DEVELOPMENT ASSESSMENT REPORT			
Application No.	10.2019.107		
Address	354 Canterbury Road, Hurlstone Park		
Proposal	Demolition of existing structures, construction of a three storey mixed use building with ground floor childcare centre, business premises and two levels of residential accommodation with 10 residential units, basement car parking, associated works and strata subdivision.		
Date of Lodgement	17 July 2019		
Applicant	Technik Haus PL		
Owner	A A Ali & M Shaikh & Z Hussain		
Number of Submissions	6		
Value of works	\$4,800,000		
Reason for determination at Planning Panel	SEPP 65		
Main Issues	Waste management/collection Car parking Bicycle parking Privacy Separation of uses		
Recommendation	Approval with Conditions		
Attachment A	Recommended conditions of consent		
Attachment B	Plans of proposed development		
Attachment C	Clause 4.6 Exception to Development Standards

1. Executive Summary

This report is an assessment of the application submitted to Council for demolition of existing structures, construction of a three storey mixed use building with ground floor childcare centre, business premises and two levels of residential accommodation with 10 residential units, b

Figure 6: Map 2 from Chapter D of DCP.

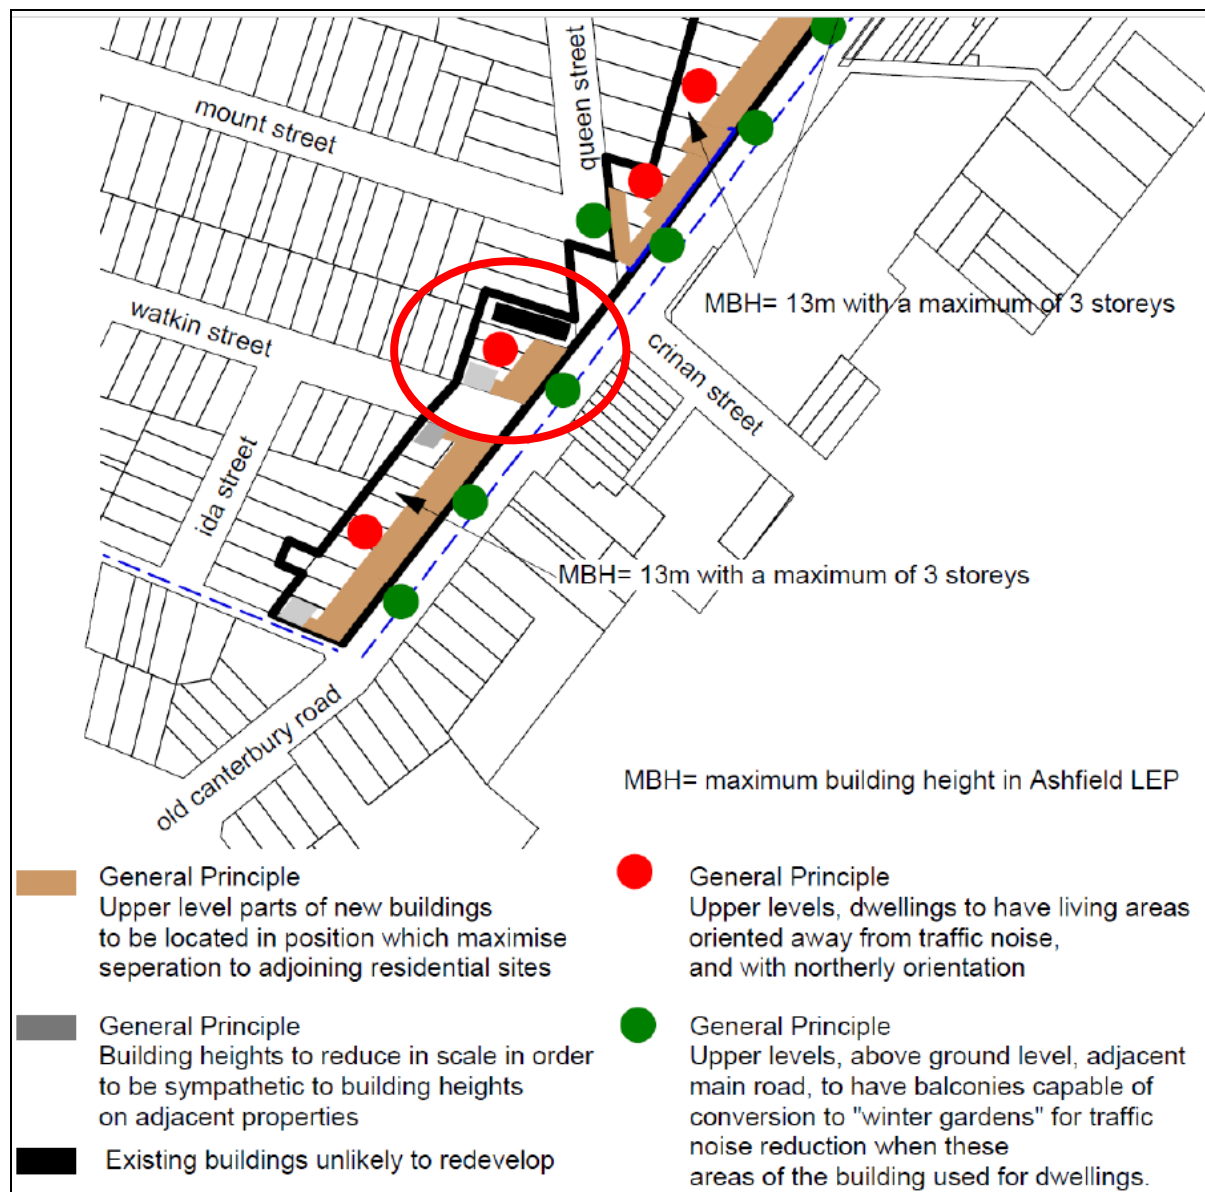
The proposal has been designed generally in accordance with Map 2 in Part 7 Chapter D of the DCP (see Figure 6 below) in that it is 3-storeys in height, has its massing located towards Canterbury Road, maintains substantial separation to the low-scale residential uses at the rear, has nil side setbacks, and the balconies fronting Canterbury Road are capable of conversion to winter gardens.

Figure 9: Area of required temporary waste storage area for residential bin collection.

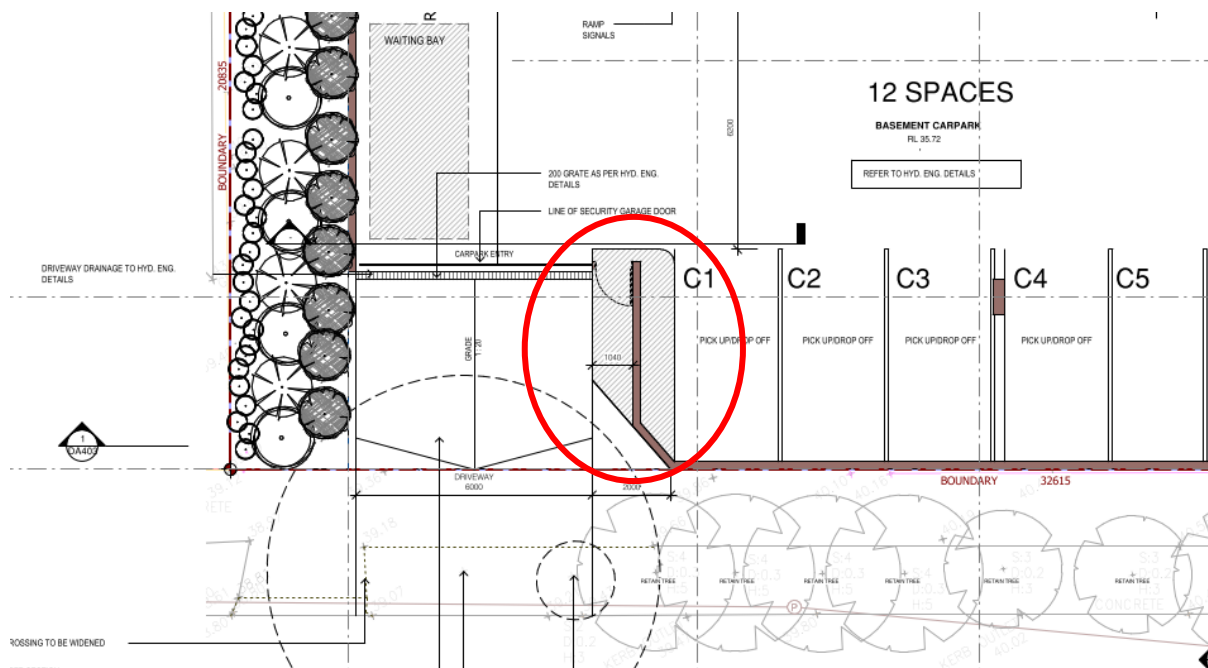
A residential waste storage area is located in basement level 1. The WMP indicates that the residential bins will be stored and collected from Watkin Street which is not desirable. It is a recommended condition of consent that an enclosed temporary waste storage area with the capacity to hold the 10 residential bins be introduced to the pedestrian area directly adjacent to the driveway (to the east) (see Figure 9 below).

This may require the relocation of the pedestrian door and/or the adjacent eastern basement wall. If additional space is required, the driveway may also be slightly relocated to the west into the landscaped area. Any reduction of landscaped area must be kept to a minimum. The temporary waste storage area must be enclosed with a roller door or similar and be designed to be integrated into the design of the building.

It will be the responsibility of strata management to transfer and return the bins to/from the collection point (the aforementioned temporary waste storage area). Conditions to this effect are recommended. The waste management plan will need to be updated accordingly.

Figure 10: Sections showing sightlines from upper level balconies.

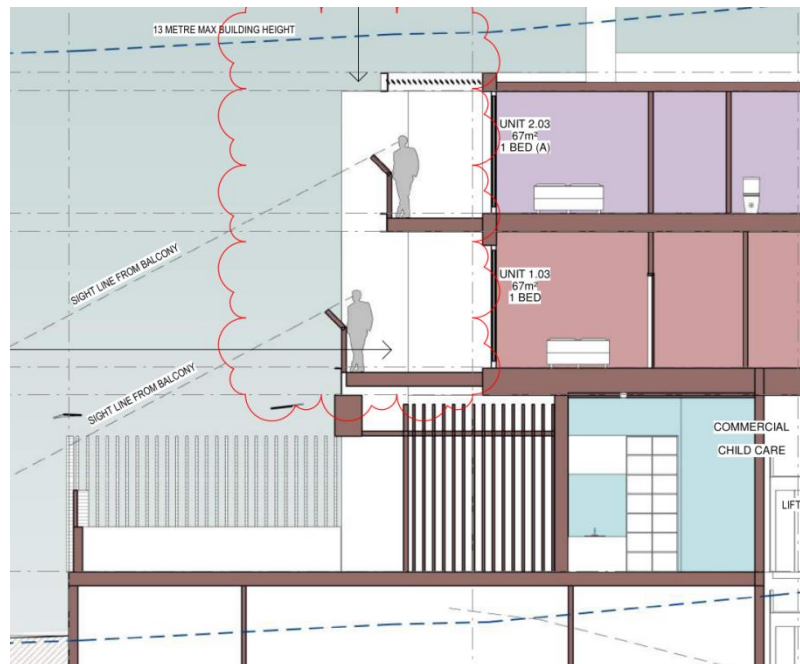
Privacy concerns were initially raised by the potential for overlooking of the outdoor play area from the upper level west-facing residential balconies. As a response, 1300mm high solid balustrades were introduced which will adequately restrict sightlines from the balconies to the outdoor play area below (see Figure 10 below). It is also noted that the outdoor play

area includes large parasails for weather protection which will also provide substantial screening of the outdoor area.

Figure 11: Red circle indicates new location of pick up/drop off spots.

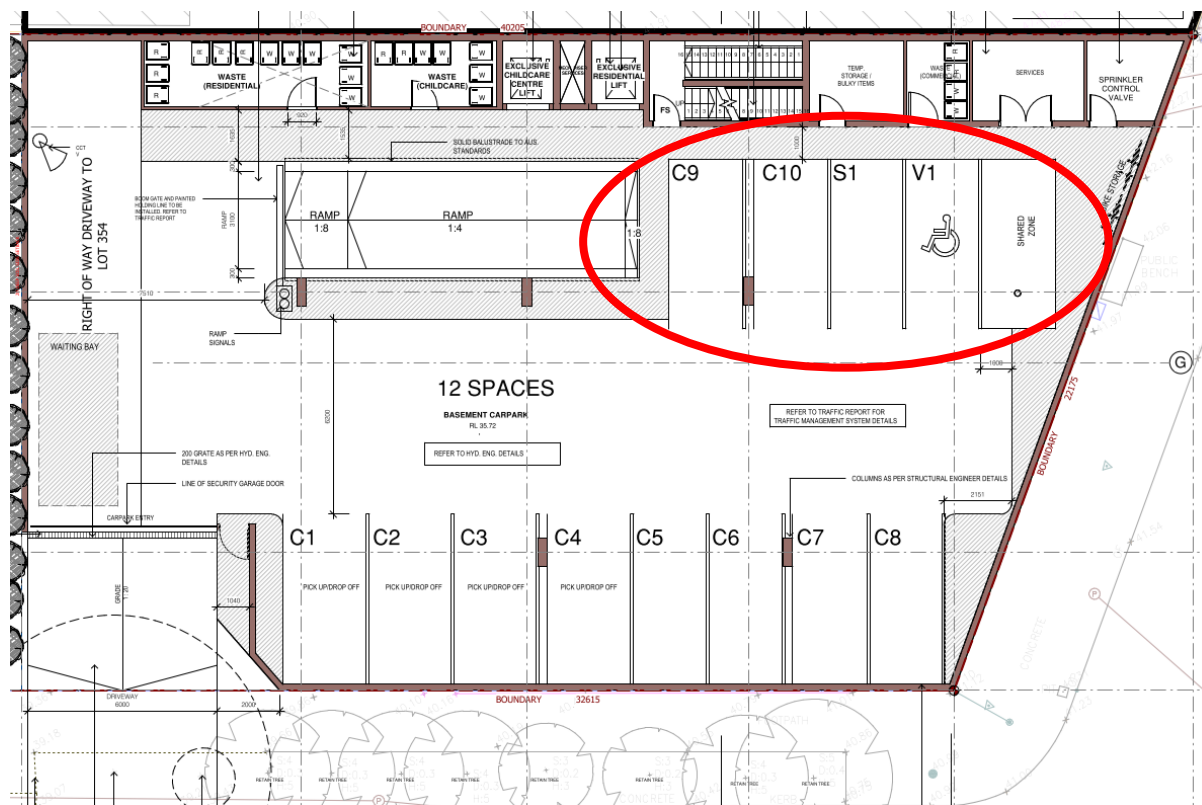
PC4 requires separate pedestrian paths with a minimum width of 1.2 metres separated from vehicle aisle movement areas or car parking spaces are provided, identified and located to allow safe movement of children with parent/carers to and from vehicles within the short stay visitor parking areas. It is a recommended condition of consent that the proposed pick up/drop off spaces be relocated to the northern four car spaces (C9, C10, S1 and V1) so they are immediately adjacent the childcare lift thus reducing possibilities for pedestrian/vehicle conflicts (see Figure 11 below).

To ensure a clear delineation between the pickup/drop off spots and the longer-term car spaces, it is a recommended condition of consent that the pickup/drop off spots are painted and clearly demarcated with signage indicating that they are for childcare pickup/drop off only.

Figure 12 Section indicating extent of lift overrun above 13m height limit (looking north)

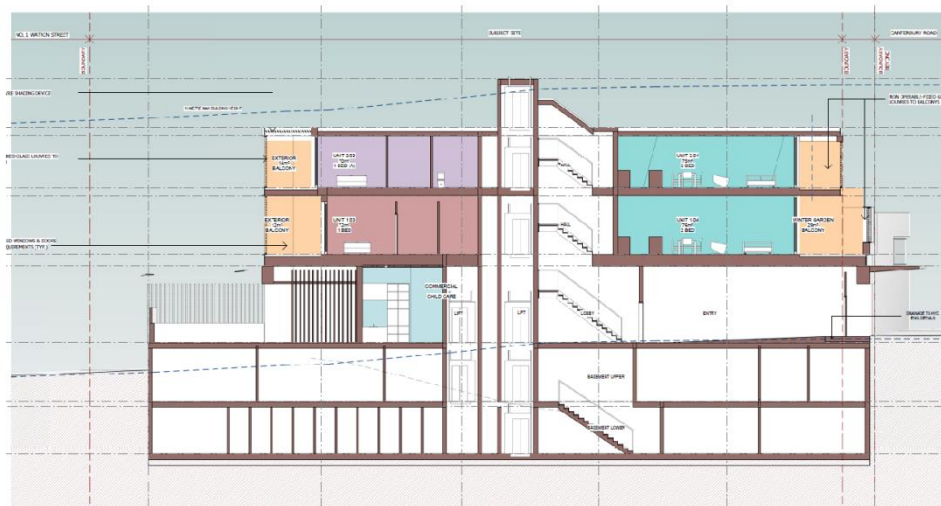
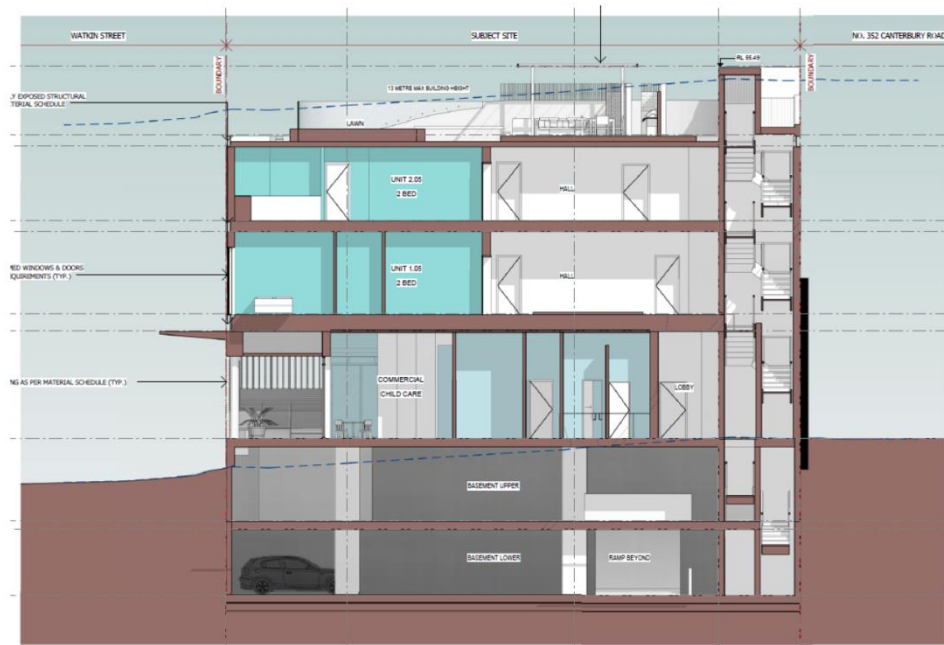
As indicated in Figures 12 and 13 below, the building largely complies with the 13m maximum building height, other than the lift overrun and the shading pergola which breaches the height limit by 379mm. The height breach occurs at the centre of the building where the lift core runs through the building. The remainder of the building complies with the height limit.
